**Report for consideration by the  
Planning and Development Control Committee**

**16 September 2020**

**HUMBERSTONE VILLAGE AREA 20MPH ZONE--**  
**OBJECTION TO PROPOSED SPEED CUSHIONS**

DRAWING No.		REV	SCALE
HT/115473C/L(0)		A	1:1500
DRAWN BY	BM	DATE	
CHECKED	RB	SIZE	
ACAD FILE	HUMBERSTONE	UPRN	n/a

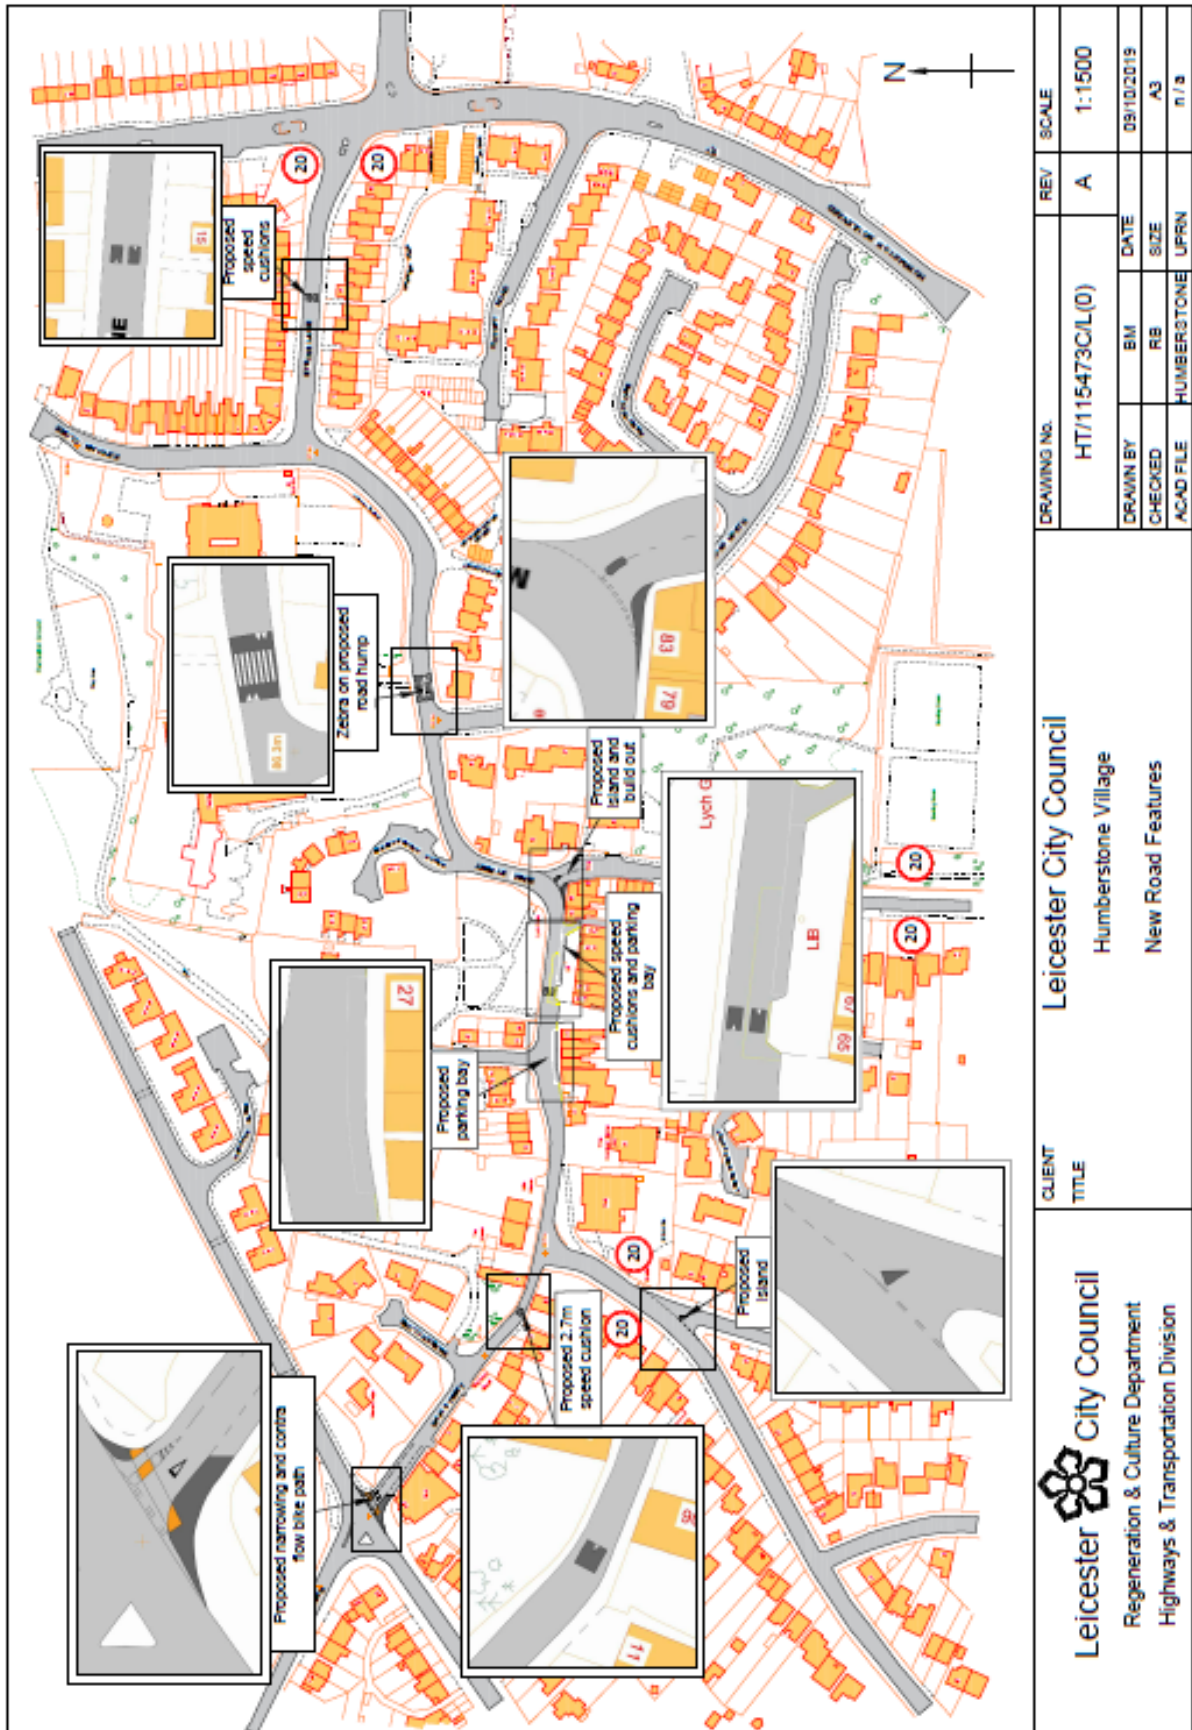
*My husband & I have no objection to the raised Zebra Speed Hump outside 101 Main Street as such. However the rest of your proposals for 3 speed cushions are totally inappropriate in our opinion. These speed cushions cause problems to tyres and suspension of normal vehicles, whilst lorries, buses & other large vehicles just carry on at speed regardless. We also notice that cars park in close vicinity, or, on them, of other speed cushions around this area causing problems for other vehicles.*

#### 5.1 ***Speed cushions cause problems to tyres and suspension of normal vehicles***

#### 5.2 ***Lorries, buses & other large vehicles just carry on at speed regardless***

#### 5.3 ***Parking on, or in the vicinity of, speed cushions***

The speed cushions we install meet current regulations. The speed cushions proposed for this area are 75 mm high. This is less than the maximum permitted height of 100mm. Vehicles that comply with the speed limit of 20 mph should not, therefore, damage tyres or suspension when passing over speed cushions at this height.

It is accepted that large vehicles and buses can, at times, straddle the speed cushions. This feature of speed cushion design helps ensure bus travel is comfortable for passengers.

Cars do indeed park on speed cushions in the way the objector describes. This is seen as a positive feature of speed cushions. Unlike some other traffic calming measures, they reduce traffic speeds without removing kerb-side parking spaces used by local residents.

- 6.1 Having reviewed the design and considered the outstanding objection, officers believe the proposed speed cushions are an appropriate traffic calming measure, consistent with the objectives of the scheme.
